**Office of Planning and
Community Development**
700 5th Avenue, Suite 2000
PO Box 34019
Seattle, WA 98124-4019

Project Description

Meeting Summary

January 21, 2016

Figure 1: Location of skybridges under review

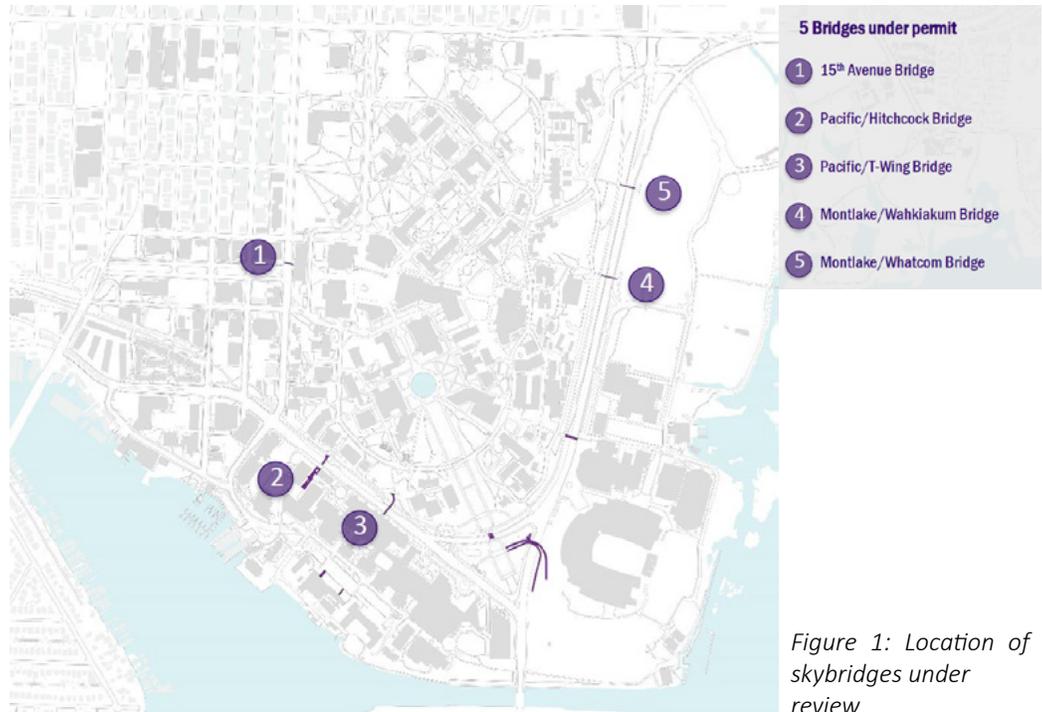
bridges. Ms. Gray said the SRC is concerned with long-term ADA accessibility with the 15th Ave Skybridge. She feels that, as part of the MIMP (Major Institutional Master Plan) process, UW should address accessibility to all bridges, regardless of location. Ms. Gray also mentioned that SRC would like to see a plan to open the wall up from the Henry Art Building to create an entrance into the main campus.

The SDC agreed the current location of the 15th Ave. skybridge is problematic as it relates to pedestrian circulation. As with other bridges located on campus, the 15th Ave. skybridge is integrated into the functionality of Schmitz Hall and The Henry Art Gallery Plaza. Commissioners encouraged the project team to reevaluate the current location and alignment of the 15th Ave. skybridge in a way that will improve the pedestrian experience while transitioning from an urban street into campus.

1. Evaluate the alignment and location of each bridge to best serve accessibility and connectivity throughout the surrounding campus and urban areas
2. Consider the location of Burke-Gilman Trail crossings with respect to the location of a potential land bridge across Montlake Blvd
3. Encourage street level porosity and an increased public pedestrian environment, as it relates to the character of the campus landscape
4. Ensure new bridge construction properly addresses the quality and character of the public environment through the establishment of a design manual or guidelines
